**Re: SSI 5414 MOD1  
North West Rail Link  
Windsor Road Bridge, Rouse Hill Modification Report**

The submission has been prepared in relation to the proposed modification of the Stage 2 State Significant Infrastructure approval (Ref. SSI-5414) granted by the Minister for Planning and Infrastructure under Part 5.1 of the Environmental Planning and Assessment Act, 1979, on 8 May 2013. The proposed modification relates to the crossing of Windsor Road, at Rouse Hill ("Skybridge").

This submission is made by The GPT Group (GPT), owners and managers of Rouse Hill Town Centre - a mixed use Major Centre under the prevailing metropolitan, sub-regional and local government strategic planning hierarchies.

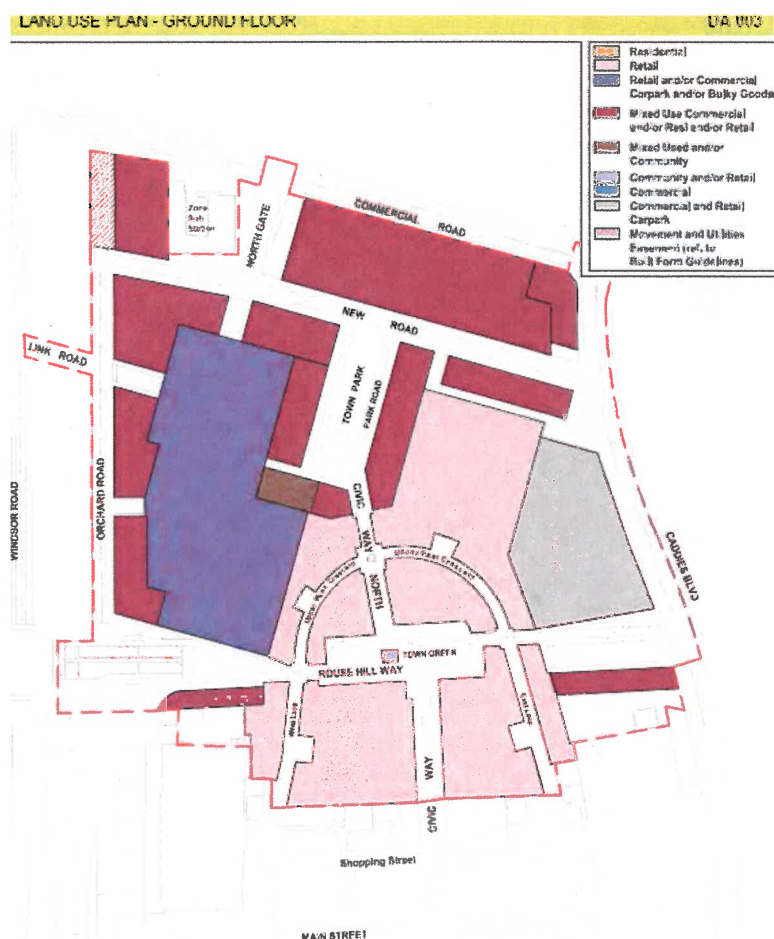
EIS 2 omits assessment to residential premises located within the RHTC and also future residential uses within mixed use buildings shown in the Northern Precinct DA. These future mixed-use buildings are located along the proposed Orchard Road within the Northern Precinct, as per the following DA drawing currently under assessment by The Hills Shire Council.
